ADDENDUM

PROJECT	BCH Helipad & Roof Replacement	PROJECT #	24003
OWNER	Boone County Hospital	DATE	6-27-24
LETTING DATE	07-02-24	ADDENDUM #	02

ASSEMBLIES
1 1/2" = 1'-0"

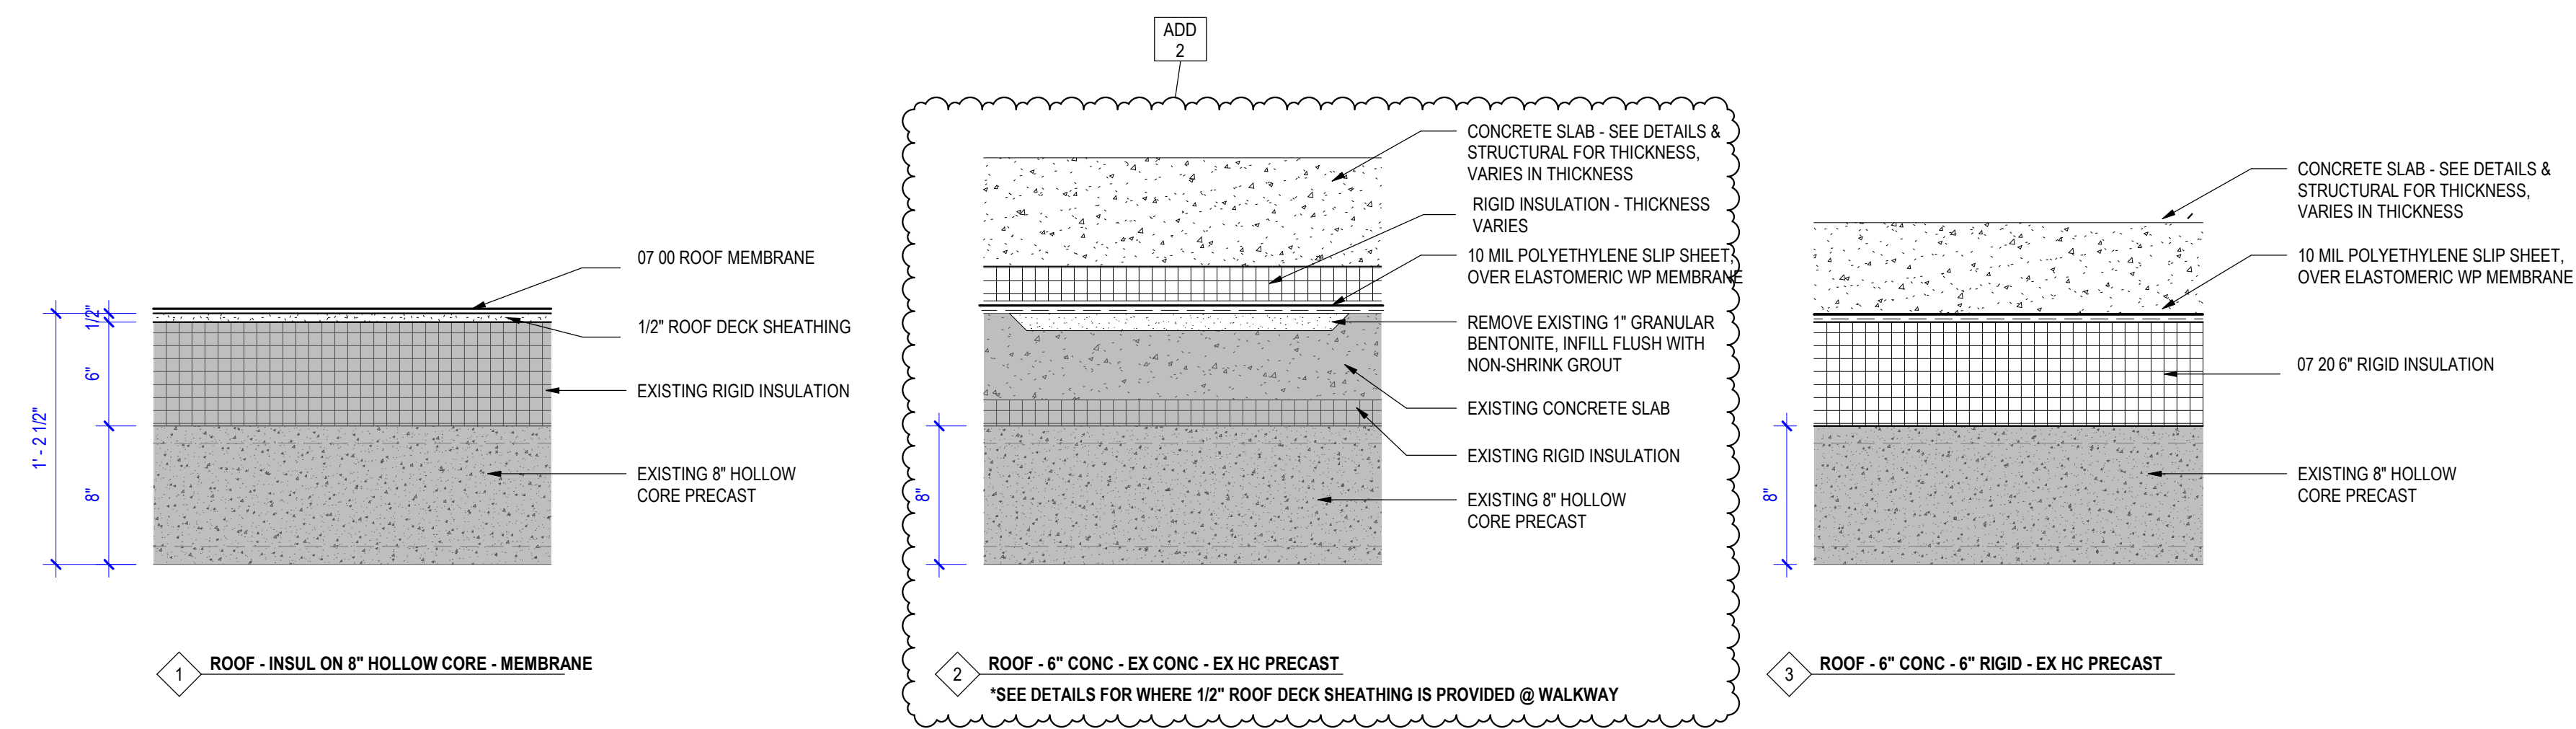
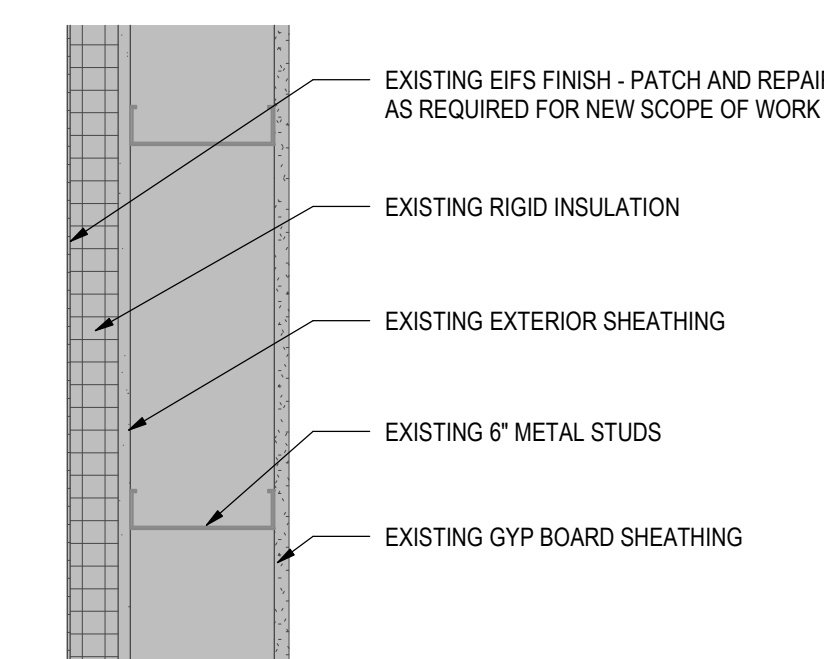
Item #	Sheet/ Section	Detail/ Paragraph	Attachment	Description of Change
2.23	A0.01	ASSEMBLIES	A0.01	REVISE to remove existing bentonite complete, infill flush with non-shrink grout
2.24	AD1.31	2	AD1.31	REVISE to remove existing bentonite complete, infill with non-shrink grout, and remove existing blocking as required
2.25	A1.31	1	A1.31	ADD detail callout for 16/A5.01 and dimension for steel grate
2.26	A5.01	6,7,10,11,12,13,14	A5.01	REVISE details 6,7,10,11,12,13, and 14 as shown in the attached documents.
2.27	A5.01	16	A5.01	ADD detail 16 HELIPAD EDGE DETAIL AT WALKWAY

2 SNOWMELT ZONE CONTROL DIAGRAM
N.T.S.

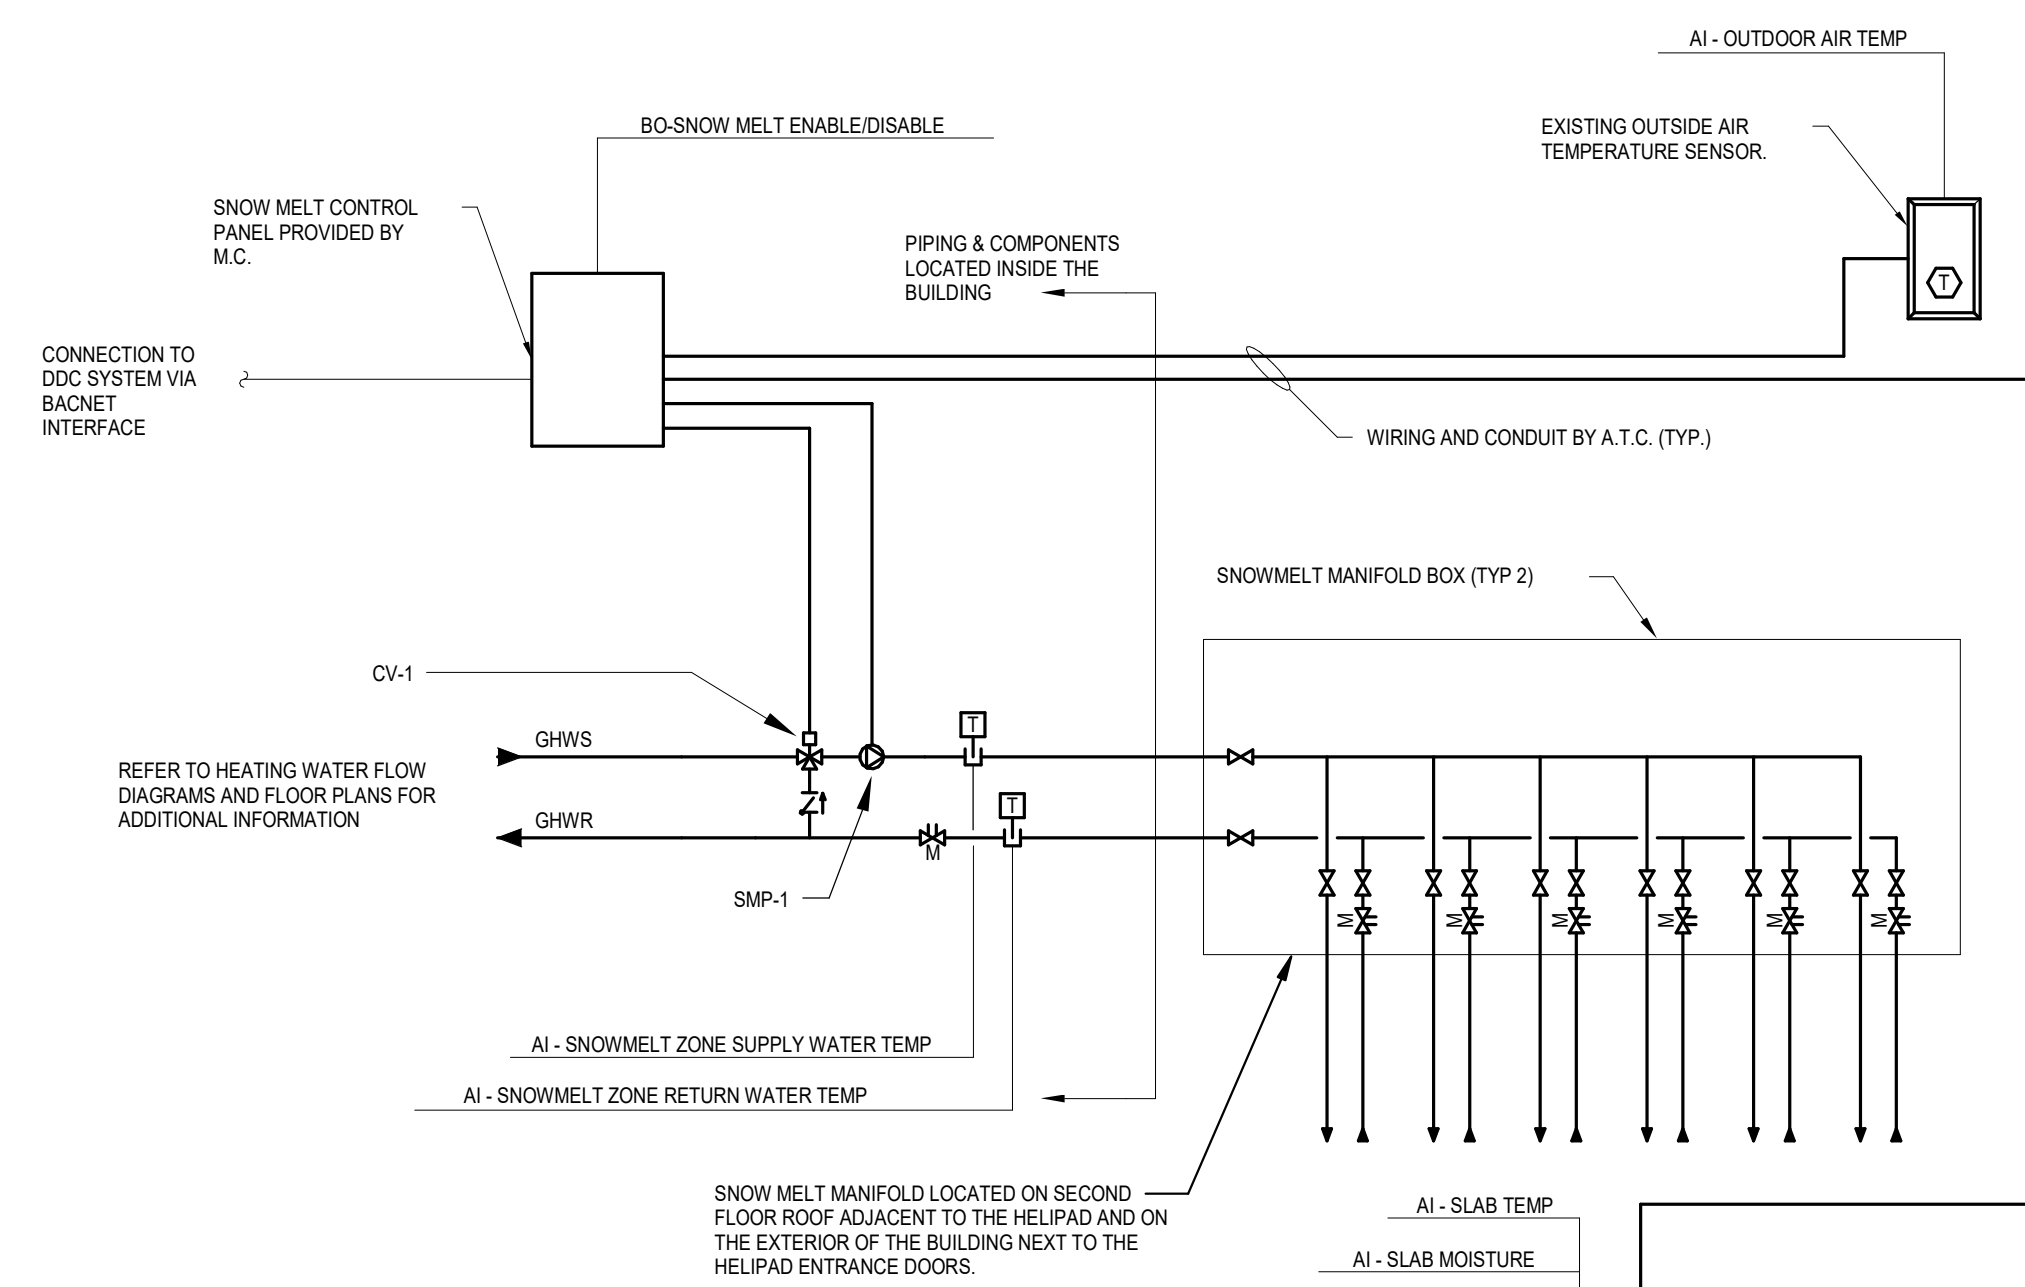
Item #	Sheet/ Section	Detail/ Paragraph	Attachment	Description of Change
3.04	M1.0	-	M1.0	REVISE keyed note #11.
3.05	M5.0	-	M5.0	REVISE snowmelt zone control diagram. REVISE roof drain detail.
3.06	M6.0	-	M6.0	REVISE glycol heating water (snow melt) material and joints in the piping application schedule. REVISE RD-1 on the plumbing material list.
